SERVICE SLANTS

ISSUED BY WURLITZER SERVICE DEPT. NORTH TONAWANDA, N. Y.

MODIFICATION OF 3020 AND 3020-(48) WALL BOX FOR USE OF 24V MOTOR, PART NO. 54186

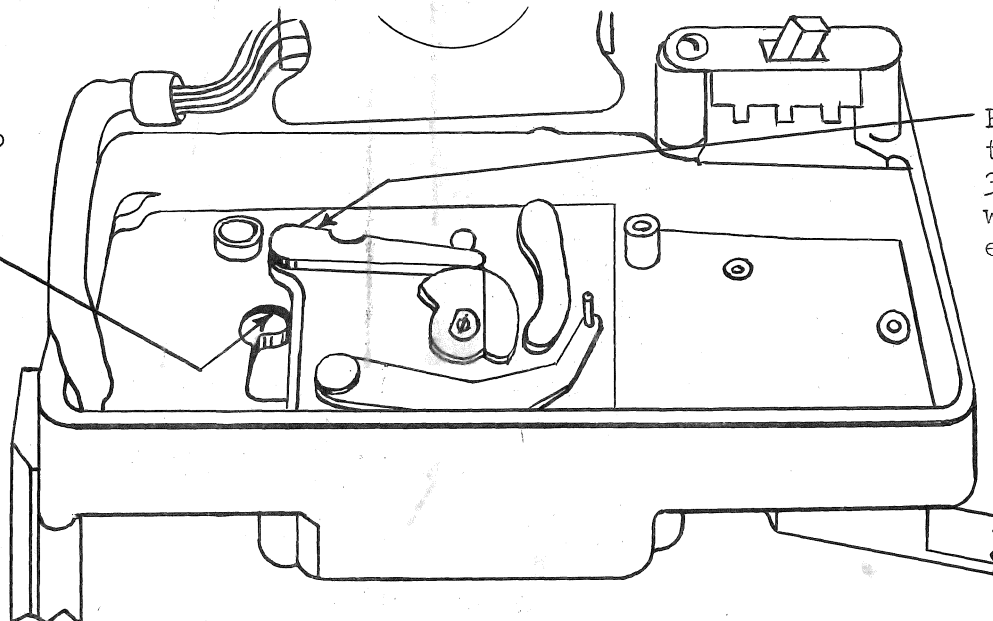
1. Remove connecting arm, Part No. 45840, to prepare for drilling.
 2. Remove old motor and drill through the two upper motor mounting holes with #27 drill. Counter-sink (82° tool) the hole under the actuating lever, Part No. 45381, to provide flush installation of #6 Flat Head Screw. Rout out casting to accomodate inner motor bearing as indicated in the figure below.
 3. From the new motor, remove the 6-32 x 1/4" Bind Head Screw, that interferes with the follower arm, Part No. 45834, from the inside motor bearing bracket. Counter-sink the hole as in par. 2 and install a 6-32 x 1/4" Flat Head Screw, flush with the surface.
 4. Mount the new motor with 1 - 6-32 x 5/8" Round Hd. and 1 - 6-32 x 5/8" Flat Head Screw.
- Assemble and adjust in accordance with Model 3020 Service Manual S-289.

1. Remove the circuit wire from No. 6 pin of the 6 pin socket and connect it to No. 5 lug of the terminal strip to provide the 24V supply for the motor. The wire from the transformer may be left on the No. 6 pin of the 6 pin socket, however, it is no longer in use as indicated by the schematic wiring diagram, W-247.
2. Remove the wire from No. 6 pin of the 11 pin (3 wire plug), Part No. 46050, and connect No. 8 pin to No. 1 pin, providing the ground circuit for 24V to supply the new motor.
3. Inspect for accuracy of changes and test for proper operation at 130V and 90V.
4. This change may be made in the early Models 3020 by following the schematic wiring diagram, W-247.

Rout out to
1/8" depth to
clear Motor
Bearing

Point at which
the screw (par.
3) interferes
with the Follow-
er Arm
